CONVERTING WILLIAMS GAMES TO 2/25¢

CONVERTING FROM (10¢-25¢) PLAY TO (2/25¢ - 2/25¢) PLAY

B-6853 COIN TRIP & SWITCH ASS'Y.

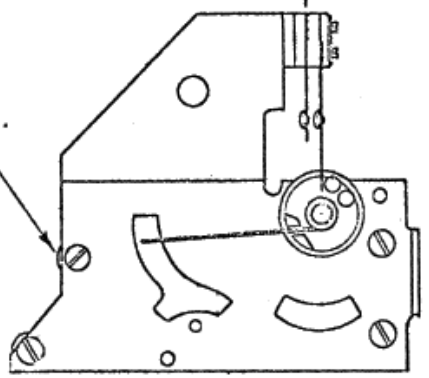
REMOVE MACHINE SCREW AND SPACER IN "COIN TRIP AND SWITCH ASSEMBLY "B-6853, TO ALLOW QUARTER TO PASS THRU.

WIRING INSTRUCTIONS

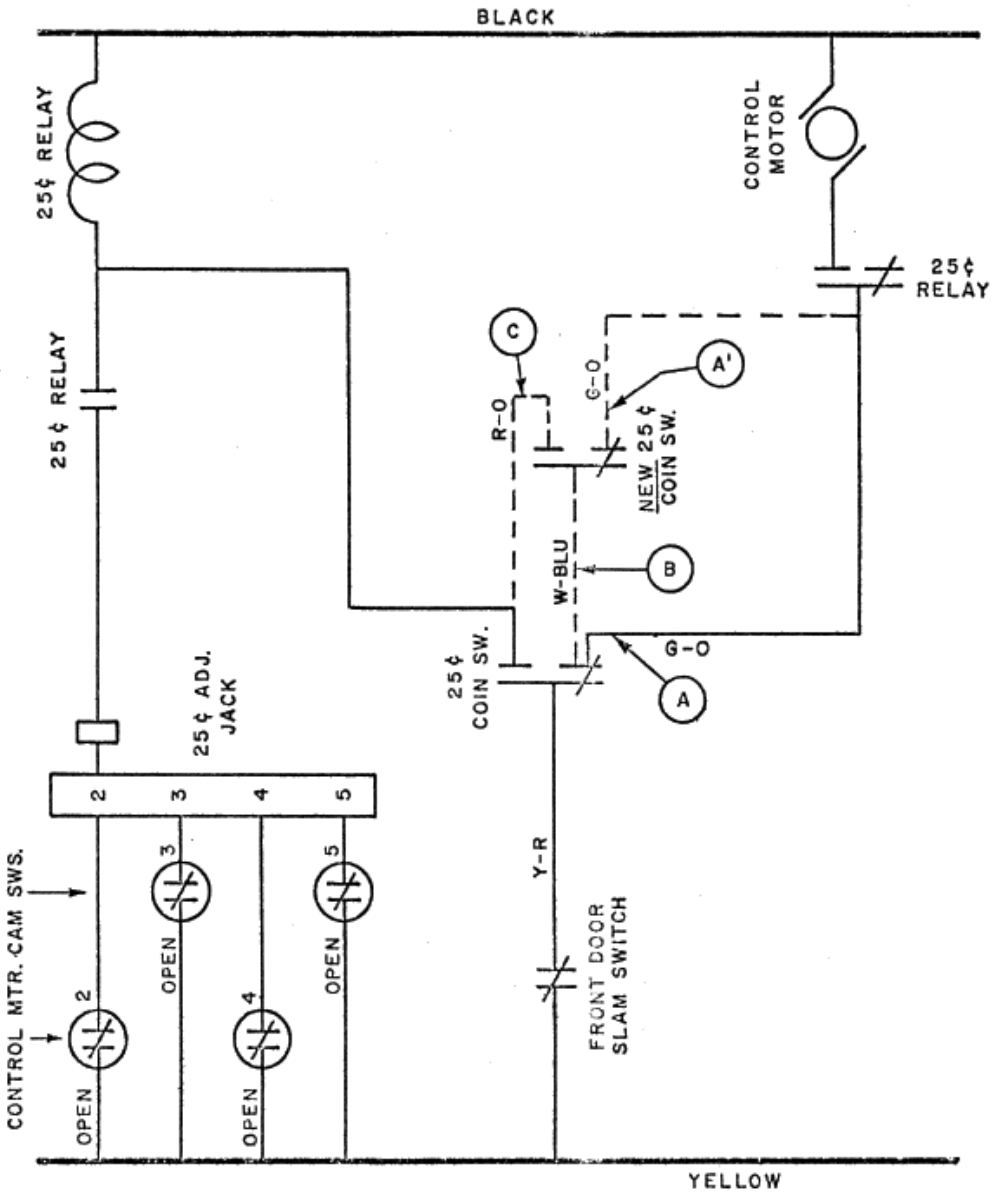
AT ORIGINAL 25¢ COIN SWITCH, UNSOLDER GREEN-ORANGE WIRE (A) AND TAPE IT. REMOVE TAPE FROM WHITE-BLUE WIRE AND SOLDER IN ITS PLACE.

AT NEW 25¢ COIN SWITCH, REMOVE TAPE FROM GREEN-ORANGE, WHITE-BLUE AND RED-ORANGE WIRES AND SOLDER AS SHOWN BY DOTTED LINES (A'), (B) AND (C).

INSERT 25¢ ADJUSTMENT JACK INTO "2 PLAYS FOR QUARTER" POSITION.
